SUBJECT: RECALL R12VH DRIVER'S SEAT BELT BUCKLE MISMATCH

Driver's Seat Belt Buckle Mismatch

Models Affected: Certain 2013 Model Year "Vision" and "All-American"

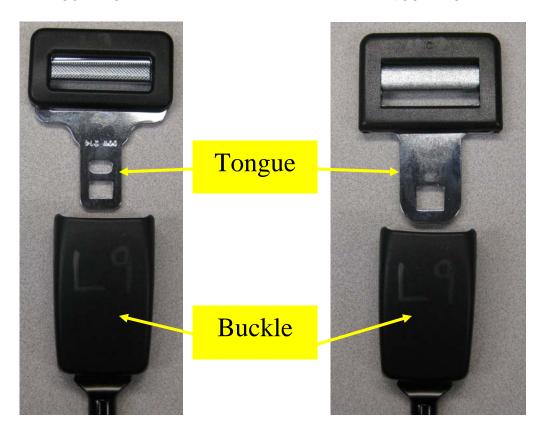
1. Compare the driver's seat belt tongue and buckle to the photos below.

Notice the wide tongue and notched buckle release

Notice the narrow tongue and notched buckle release

Notice the narrow tongue and flat release.

Notice the wide tongue and flat release.

Inspect for proper match of seat belt tongue and buckle. If incorrect, change buckle to match the seat belt tongue.

Modification Instructions A

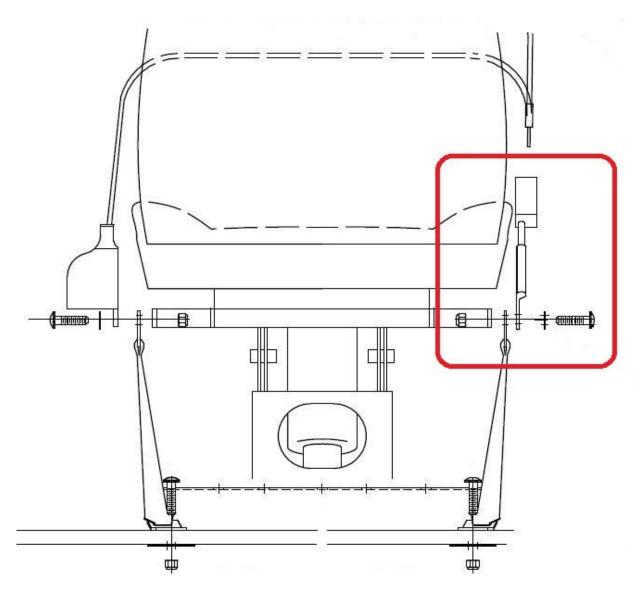
- 1. Park the bus on a level surface, apply parking brakes, remove ignition key.
- 2. Locate driver's seat belt buckle on right side of driver's seat. Remove and retain the 7/16" bolt securing the buckle to the seat frame. Discard the lock nut and buckle.
- 3. Install new buckle with new lock nut and torque to 37-41 ft- lbs. Verify belt tongue locks securely into buckle and matches per previous photos.

Reference installation drawing below as viewed from the rear of the driver's seat.

Modification Instructions B

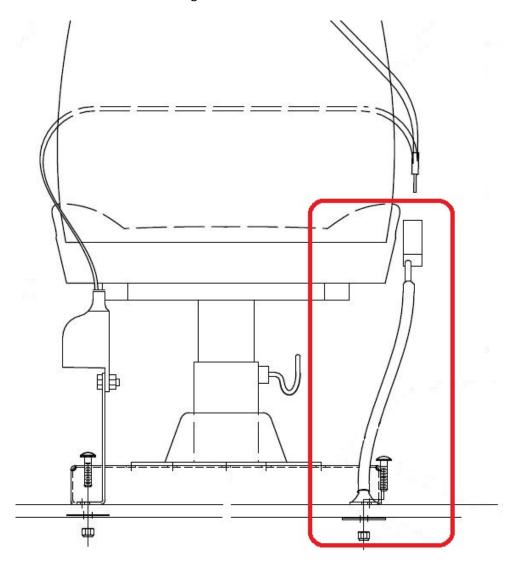
- 1. Park the bus on a level surface, apply parking brakes, remove ignition key, and chock wheels.
- 2. Locate driver's seat belt buckle on right side of driver's seat. Remove and retain the 7/16" bolt securing the buckle to the floor of the bus. Discard the lock nut and buckle.
- 3. Install new buckle with new lock nut and torque to 37-41 ft-lbs. Verify the buckle is routed through the cable stay, belt tongue locks securely into buckle and matches per previous photos.

Reference installation drawing below as viewed from the rear of the driver's seat.
